IEC 61375-2-3 Edition 1.0 2015-07

ELECTRONIC RAILWAY EQUIPMENT – TRAIN COMMUNICATION NETWORK (TCN) –

Part 2-3: TCN communication profile

CORRIGENDUM 2

5.3.2.3

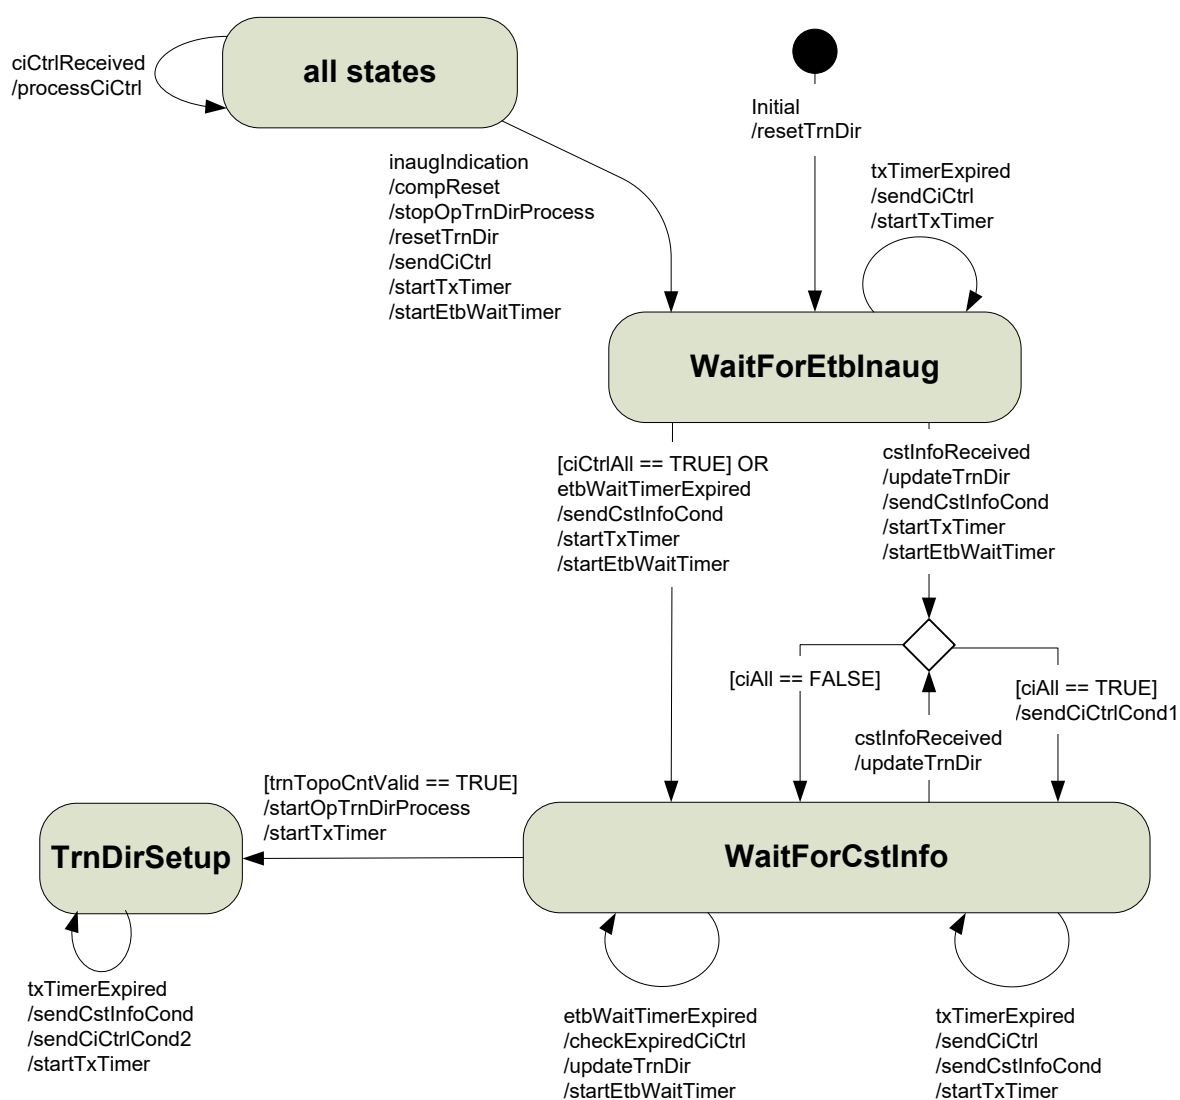
Replace existing Figure 15 by the following new Figure.

Table 5

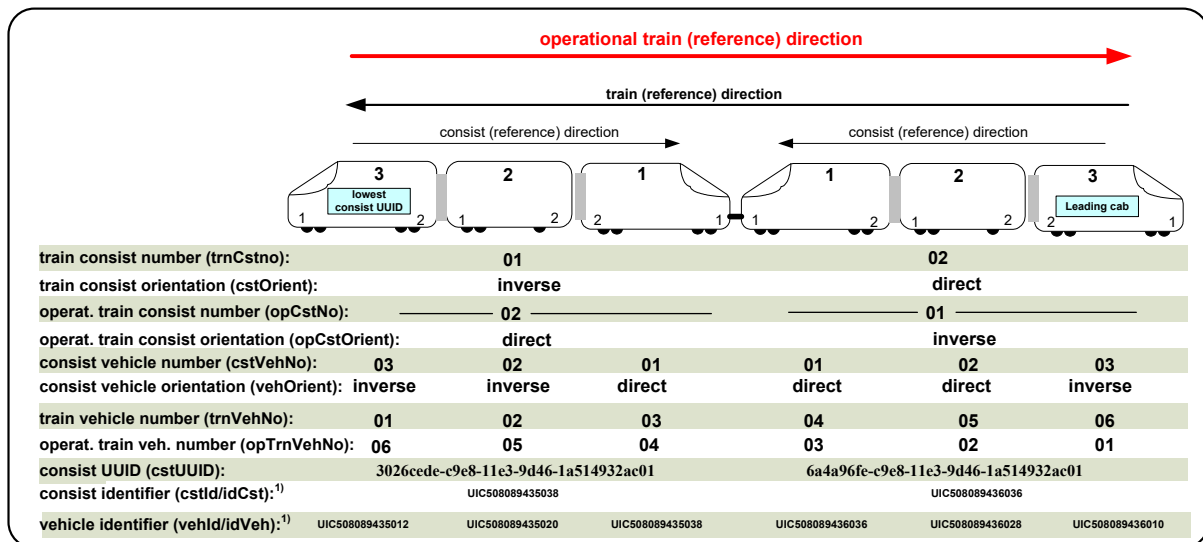
Add the following entry at the end of the table.

Action	Description
compReset	Reset the composition by triggering the event 'compReset' in the leading function state machine (see 6.5.3.2) and the confirmation/correction state machine (see 6.6.4).
